Jackson Hole, Wyoming Environmental Restoration Feasibility Report

Comment Response Package
Environmental Assessment
Finding of No Significant Impact
Monitoring Plan

**Final
July 2000**

Figure 6-1. All Four Areas - Fish Habitat Unit Projections.

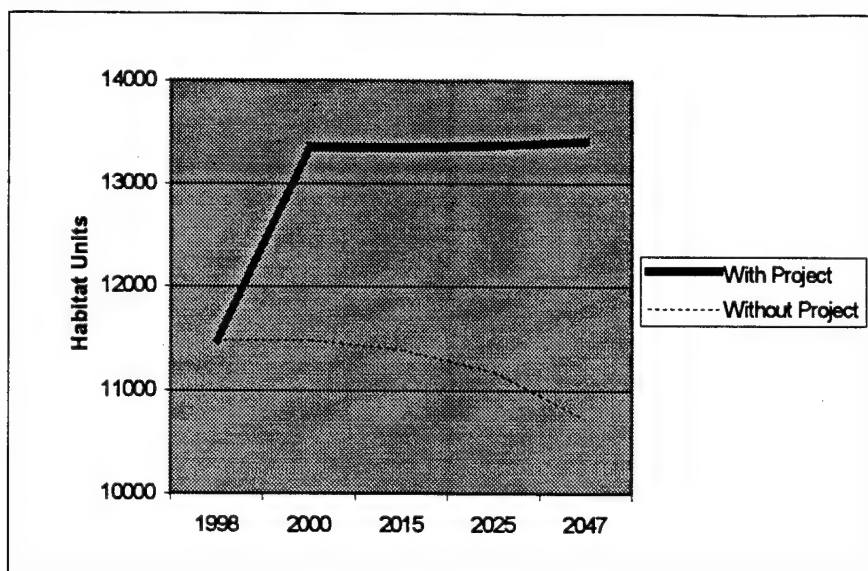
18 6.2.1.1 Cutthroat Trout (Habitat Quantity and Quality Assessment) -- How the assessment of habitat units (with and without project) was determined is unclear. Though the relationships shown in Figure 6-1 may be accurate for a given site, the benefit of this project to the Snake River system as a whole will be negligible and should be noted. Also, unless there is a high level of maintenance on these created habitats, they too will degrade over time.

Comment 18: Figure 6-1 represents a combined estimate of fish habitat unit projections for the four restoration areas and, therefore, is not intended to represent any single site. The Corps recognizes that each site is different and that the quantity and quality of fish habitat that may be restored will vary from site to site. The Corps also recognizes there are numerous areas along the Snake River that could benefit from restoration efforts and that any benefits derived from restoration in the four areas would be a small portion of any overall potential benefits. Monitoring would be used to assess the level of maintenance necessary for the various tools.
